ADDENDUM #3
ADAMS COUNTY ADMINISTRATION BUILDING
SITE AND BUILDING IMPROVEMENTS
PROJECT 21993005
October 28, 2025

ADAMS COUNTY ADMINISTRATION BUILDING SITE
AND INTERIOR IMPROVEMENTS
FRIENDSHIP, WI

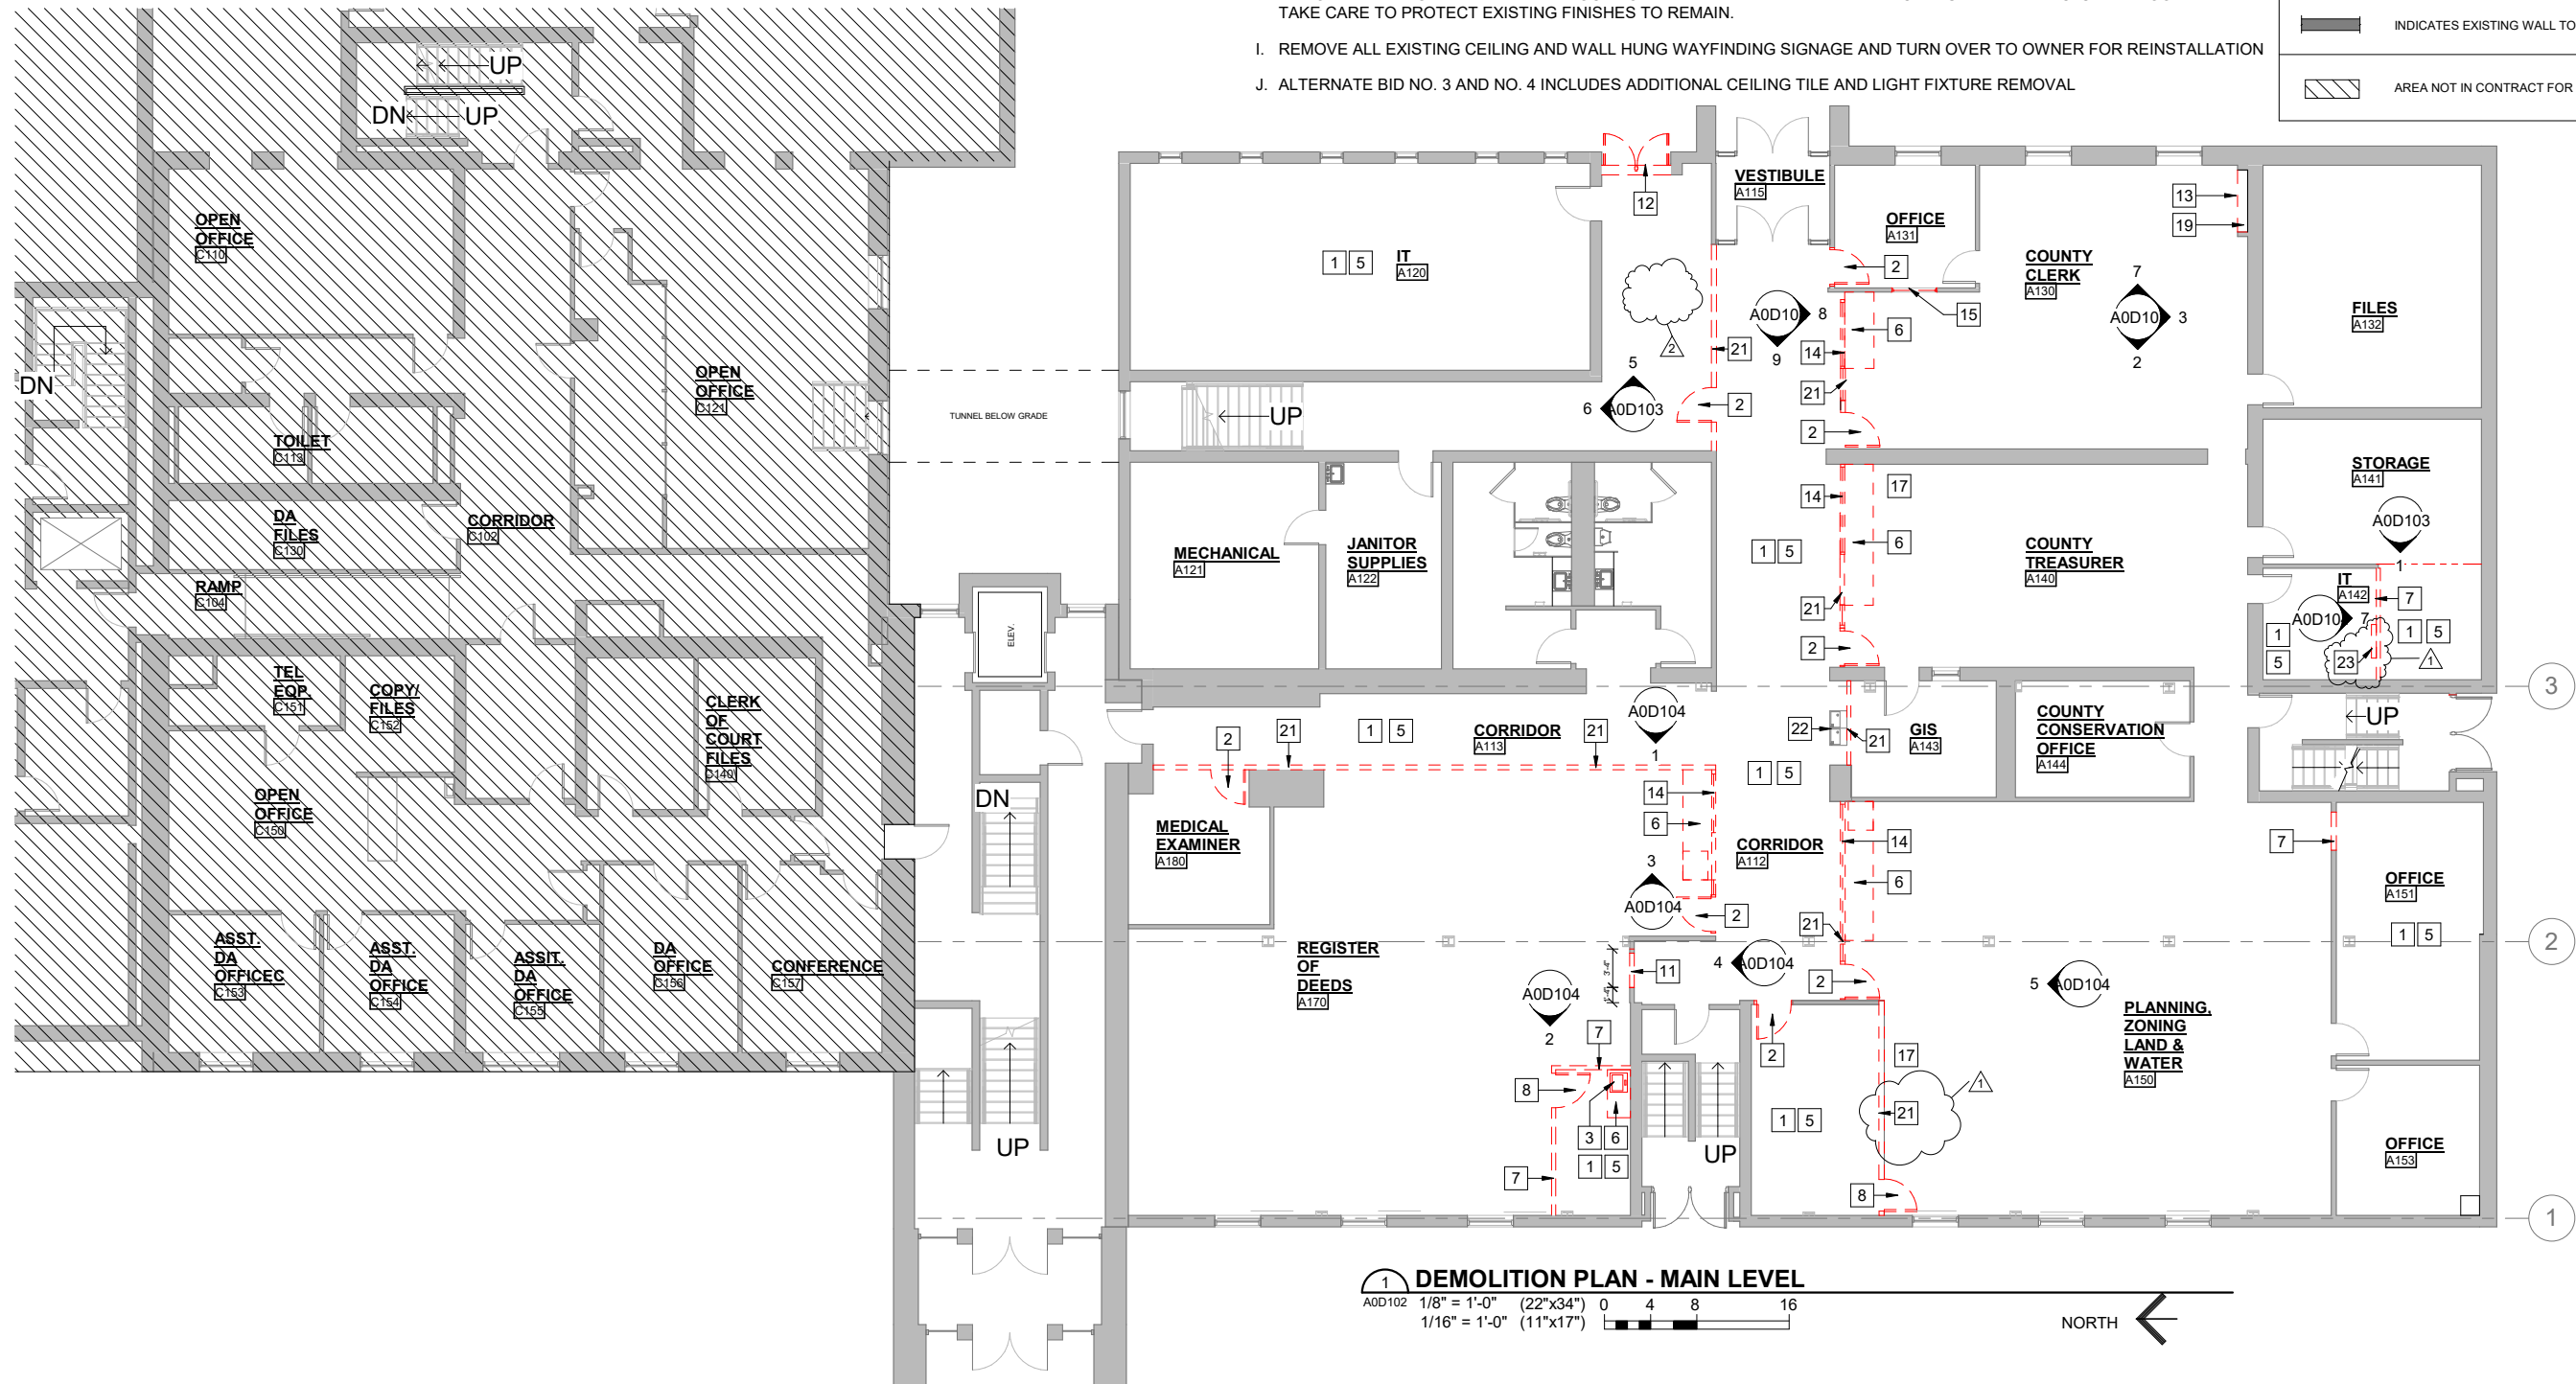
- For Rooms A040 and A041 corrected the existing ceiling type to be removed and its height.
- Adds Finish Schedule general note clarifying that that all base bid ceilings get new ceiling grid all alternate bid ceilings reuse and provide alterations as needed to address remodeling interface and revised lighting.
- For Room A119, adds Finish Schedule remark 3,4,5,6, thus clarifies work in the Alternate Bids. Also add remark 7; east wall paint is base bid.
